# CALIFORNIA ACADEMY OF SCIENCES

## FINAL ENVIRONMENTAL IMPACT REPORT

SAN FRANCISCO PLANNING DEPARTMENT

2002.0782E

**CALIFORNIA ACADEMY OF SCIENCES PROJECT**  
**FIGURE 17 (REVISED): VIEWPOINT LOCATIONS**

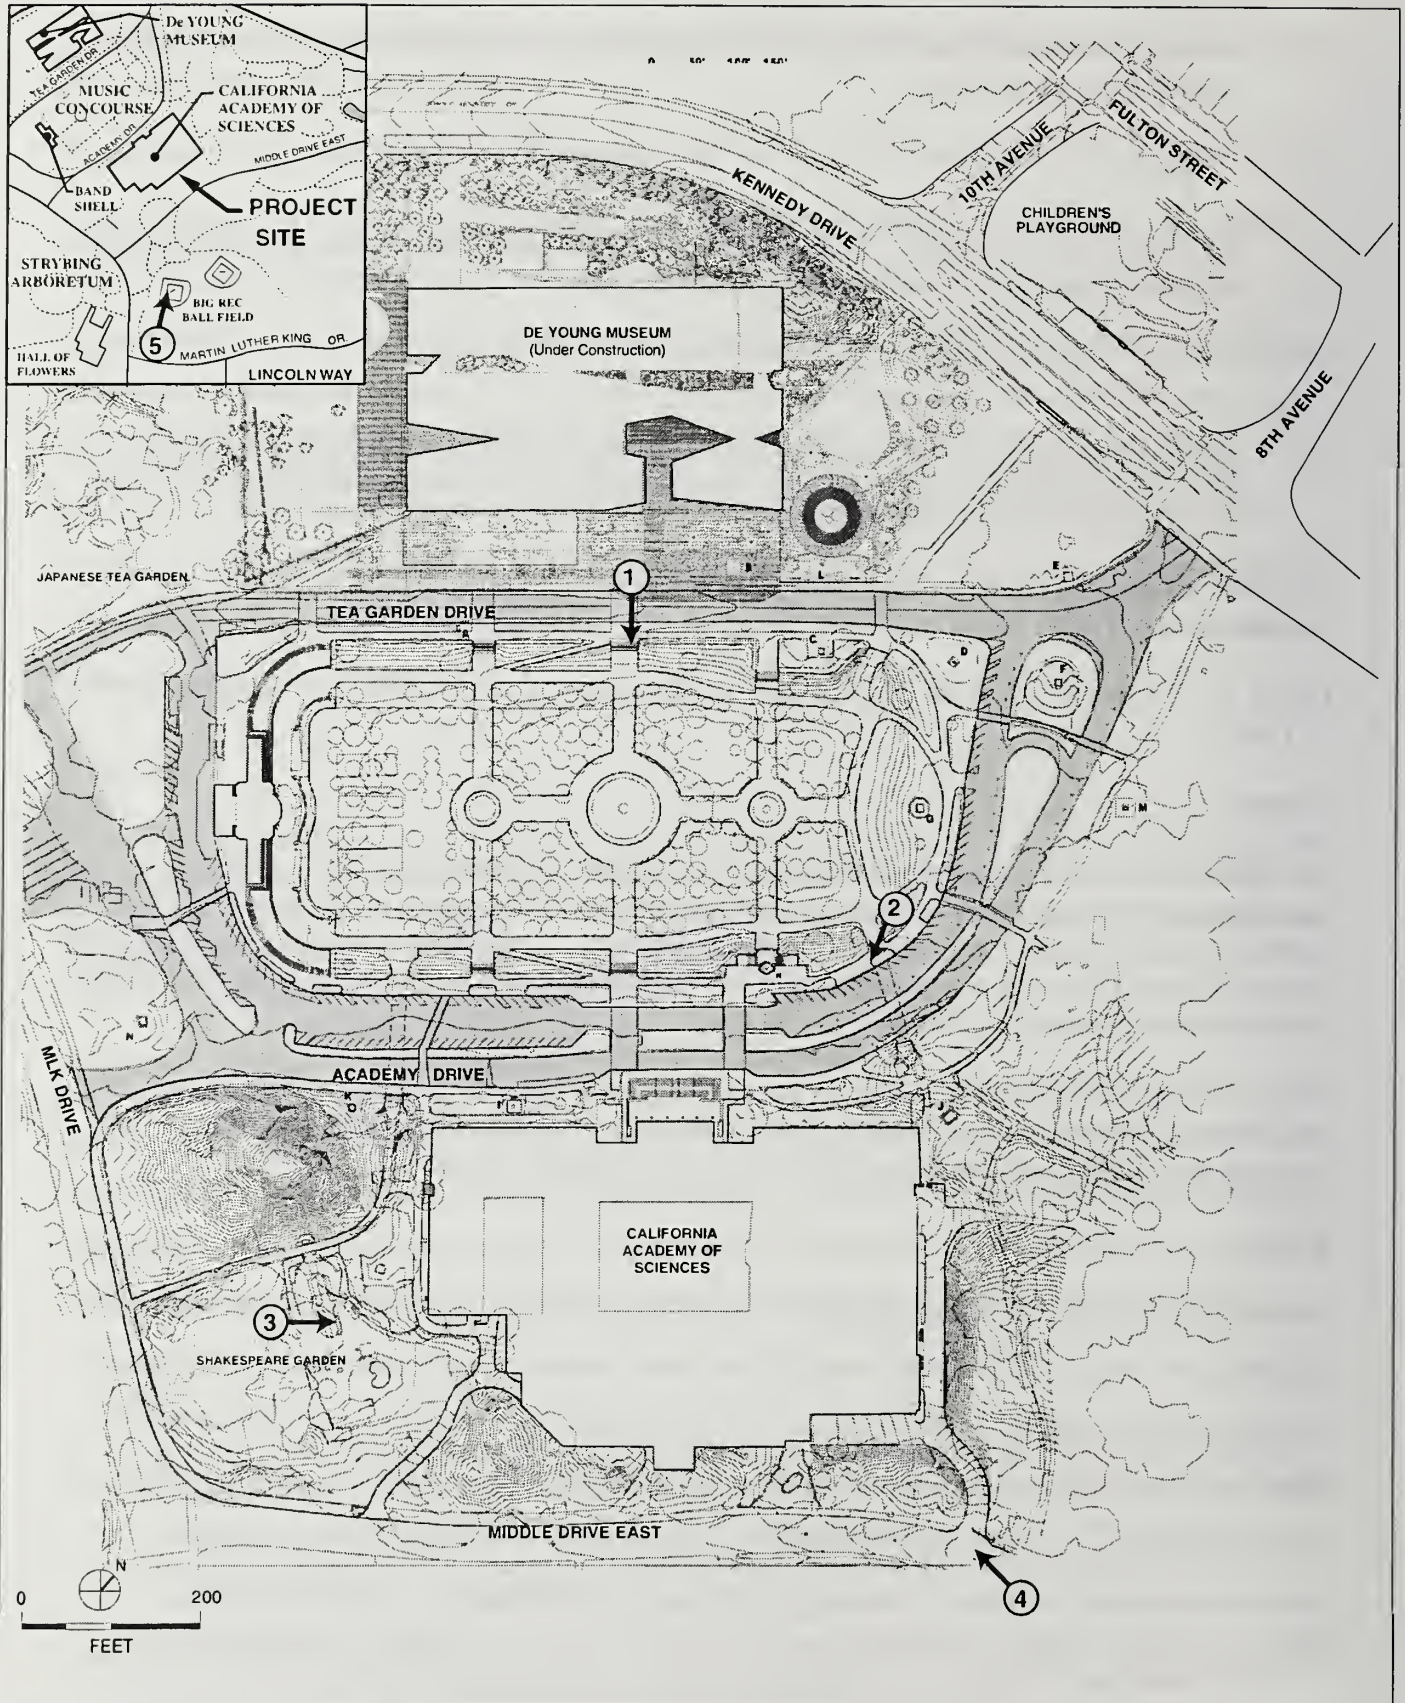
There should be an additional image of the existing buildings and of the proposed structure that affords a clearer, closer view of at least part of the façades, so that one can really compare the existing and the proposed structures. (*Michael Levin*)

Figure 17 (Revised), DEIR p. 126, Viewpoint Locations, is shown below to include the location of new Figure 21.1.

Section III.D, Visual Quality, DEIR pp. 132-133 describes views of the proposed Academy, including the retained Simson African Hall and other features of the new design. The text describes the relationship of the Academy to the surrounding landscape of Golden Gate Park, and concludes that the project would not have a significant adverse effect of visual quality. As noted on DEIR p. 132, the visual simulations include basic architectural and landscape elements that would be incorporated in the project and illustrate the overall height and massing. Further architectural detail is not provided and is not required for adequate analysis
